**TO:** Richmond City Council  
**FROM:** Councillor Malcolm Brodie, Chair  
Planning Committee  
**RE:** **APPLICATION BY DAVA DEVELOPMENTS LTD. FOR REZONING AT 4591 NO. 5 ROAD FROM SINGLE-FAMILY HOUSING DISTRICT, SUBDIVISION AREA (R1/E) TO SINGLE-FAMILY HOUSING DISTRICT, SUBDIVISION AREA C (R1/C)**

**FILE:** 8060-20-7200

**TO:** Planning Committee  
**FROM:** Joe Erceg  
Manager, Development Applications  
**RE:** Application by Dava Developments Ltd. for Rezoning at 4591 No. 5 Road from Single-Family Housing District, Subdivision Area E (R1/E) to Single-Family Housing District, Subdivision Area C (R1/C)

Attachment 2

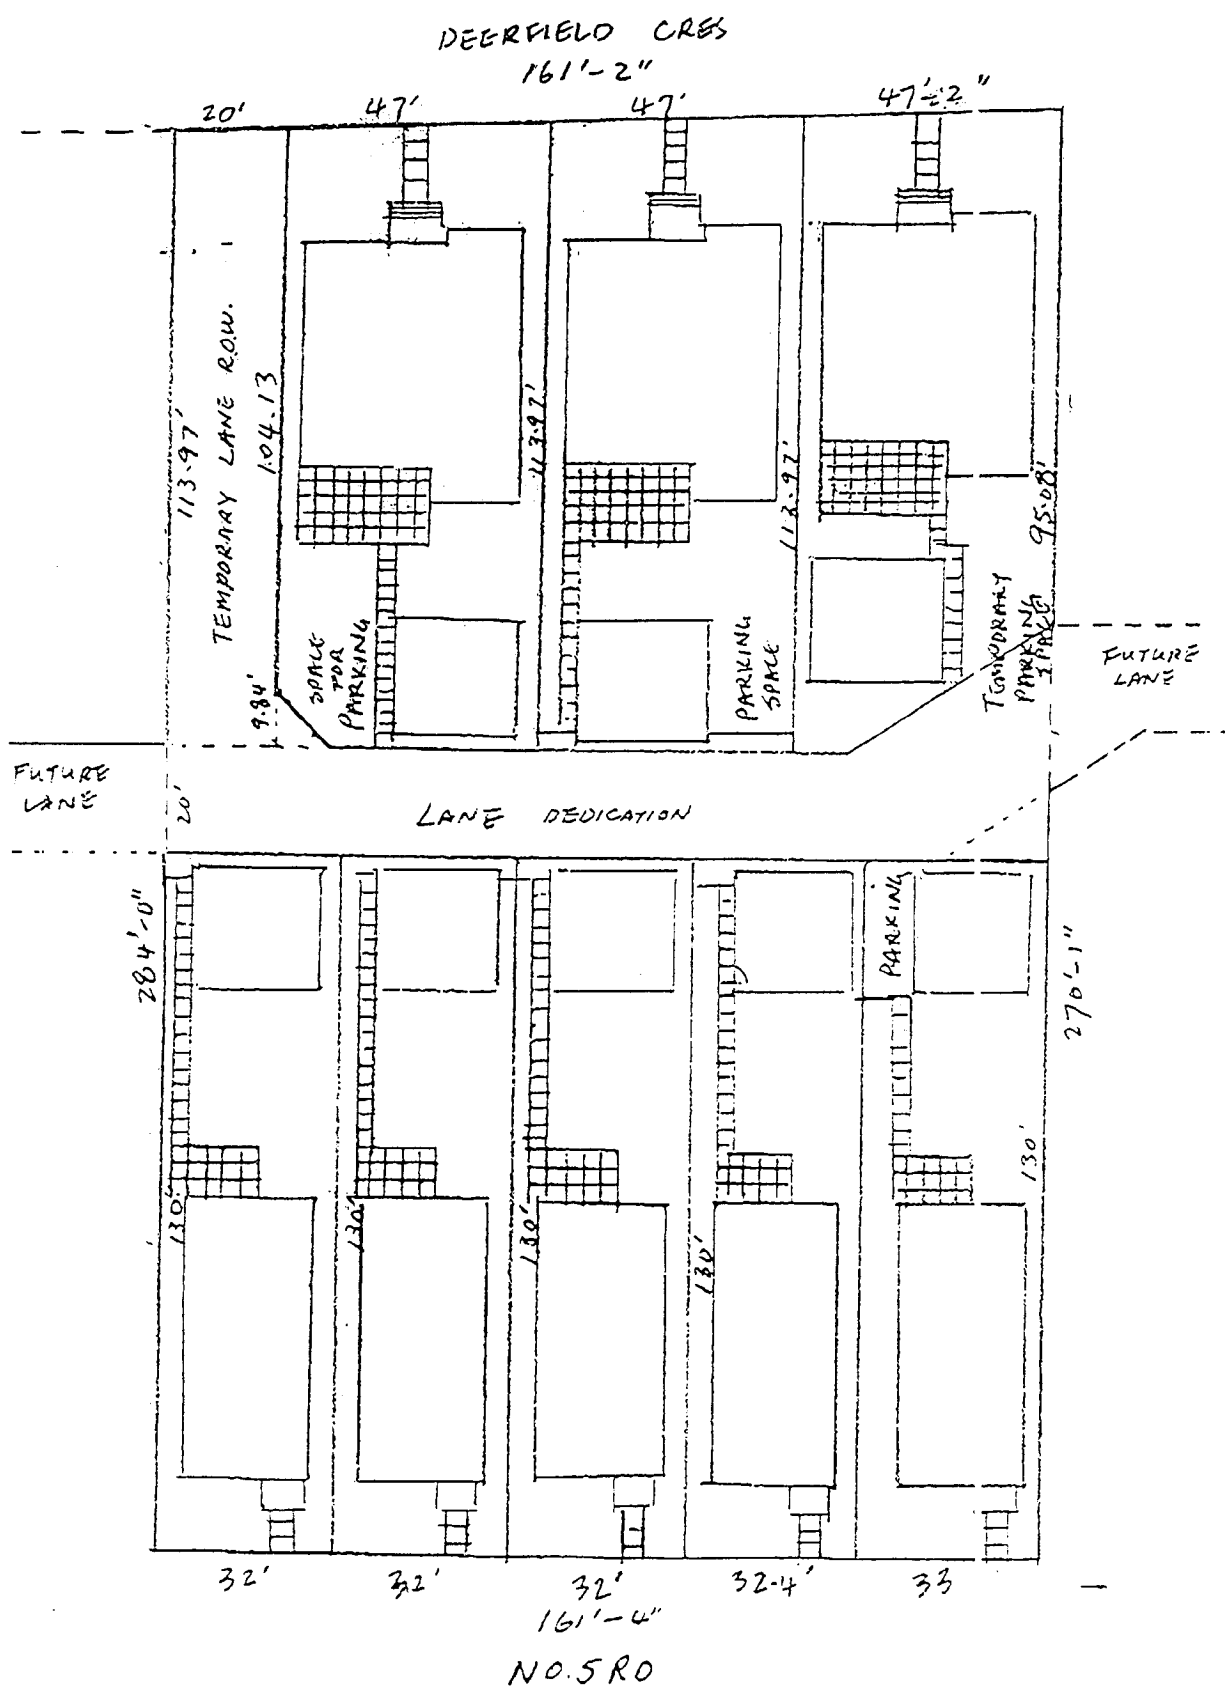
***That Bylaw No. 7200, for the rezoning of 4591 No. 5 Road from "Single-Family Housing District, Subdivision Area E (R1/E)" to "Single-Family Housing District, Subdivision Area C (R1/C)" and "Single-Family Housing District, Subdivision Area A (R1/A)", be referred to a Public Hearing prior to which Attachment 2 of the staff report would be amended to:***

- (a) move the temporary lane access from Deerfield Crescent to No. 5 Road and relocate the access to the middle of the property;***
- (b) increase the width of the lots fronting Deerfield Crescent;***
- (c) recess the garages for lots fronting No. 5 Road by a minimum of ten feet from the lane; and***
- (d) amend the rezoning requirements accordingly, including registration of a "no build" covenant on the lot containing the temporary lane access.***

At the April 3<sup>rd</sup> Planning Committee, the development proposal for an 8 lot subdivision at 4591 No. 5 Road was amended to:

- move the access to the lane from Deerfield Crescent to No.5 Road. This access is to be located on one of the middle five newly-created lots until such time as a permanent lane access is available to Dewsbury Drive. At that time a no-build covenant would be released by the City to enable the lot to be developed;
- increase the width of the three new lots fronting Deerfield; and
- create additional parking areas for the lots fronting No.5 Road by moving the garages 10 feet in from the edge of the lane.

NO. 5 ROAD STREET ELEVATION

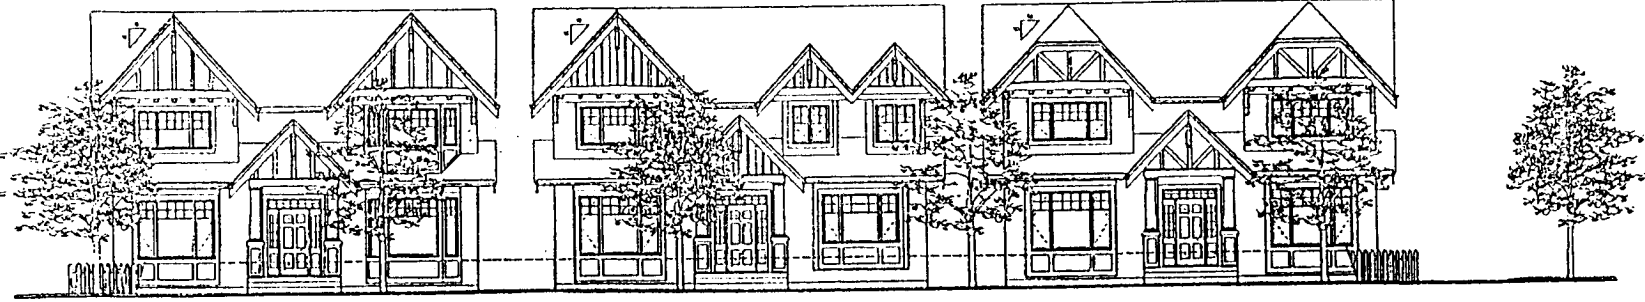
During the meeting when we met with the neighbours on R2 rezoning of this property, some neighbours are concerned about the devaluation of their land if their neighbouring properties are rezoned to R2. For R2 zoning that concern is debatable because of the Deerfield frontage but for our R1C/R1A zonings the end result is a definite upgrade to the neighbourhood. When you are in the Deerfield subdivision itself, you can now see new houses similar to the size of houses across the street. On No.5 Road you can also see new houses similar to houses across the street. Now all the large lots on No.5 Road can see their value going up because there is the possibility of rezoning their lots to smaller ones. Schedule B shows the street elevations of both the Deerfield and No.5 Road frontage. They are looking great!

Attachment 1 reflects these changes.

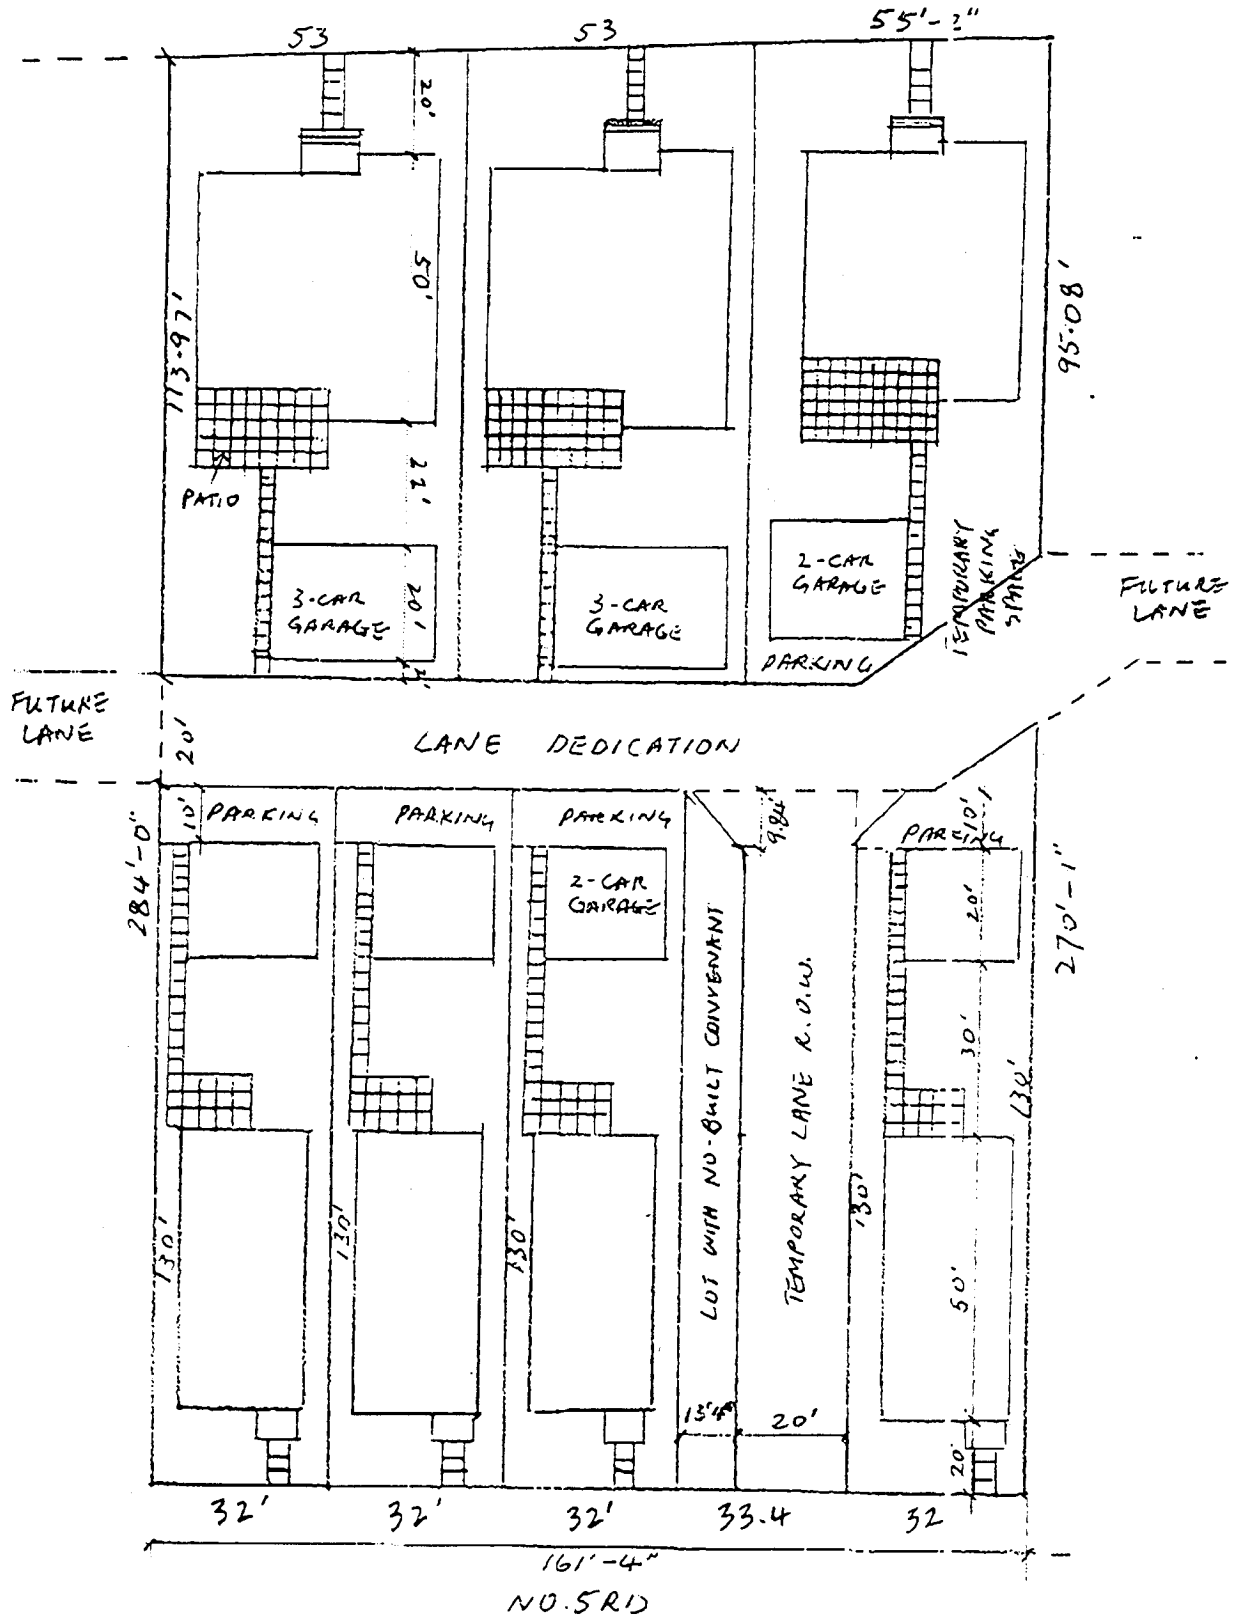
- a right of way from the lane to No.5 Road, rather than Deerfield Crescent.
- a no-build covenant on the lot used for lane access until such time as the access is relocated.
